## SYDNEY NORTH PLANNING PANEL COUNCIL ASSESSMENT REPORT

<b>Panel Reference</b>	2018SNH032
<b>DA Number</b>	DA2018/0995
<b>LGA</b>	Northern Beaches Council
<b>Proposed Development</b>	Subdivision of land into 2 allotments, demolition of existing structures, and construction of a mixed use development containing 78 Seniors Housing units, and commercial space
<b>Street Address</b>	Lot CP SP 49558, 5 Skyline Place, Frenchs Forest
<b>Applicant</b>	Platino Properties
<b>Owner</b>	The Owners Of Strata Plan 49558
<b>Date of DA lodgement</b>	16 June 2018
<b>Number of Submissions</b>	18 (17 objecting to the proposal and 1 in support of the proposal)
<b>Recommendation</b>	Refusal
<b>Regional Development Criteria (Schedule 7 of the SEPP) State and Regional Development) 2011</b>	Development with a Capital Investment Value (CIV) of more than \$30 million  Total Cost of the Development is <u>\$41,144,040</u>
<b>List of all relevant s4.15(1)(a) matters</b>	<ul style="list-style-type: none"> <li>• Environmental Planning and Assessment Act 1979</li> <li>• Environmental Planning and Assessment Regulation 2000</li> <li>• State Environmental Planning Policy No. 55 – Remediation of Land</li> <li>• Sta

**Figure 2 – Proposed/Existing Buildings and Subdivision Layout** (Source: Adapted by the author of the Plans, prepared by PA Studio)

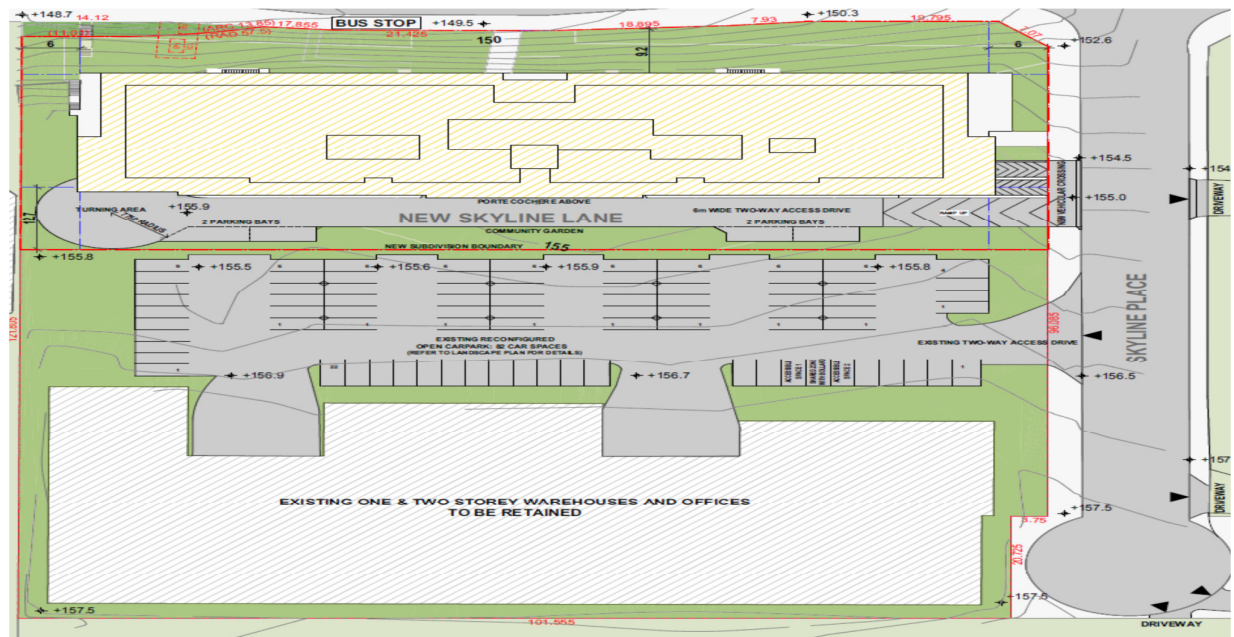
The proposed street wall style of development adds significant continuous building mass to an otherwise open streetscape, which is characterised by warehouse/office type on the southern side of road and by traditional dwelling house built forms on single allotments on northern side of the road, which provide substantial building separation
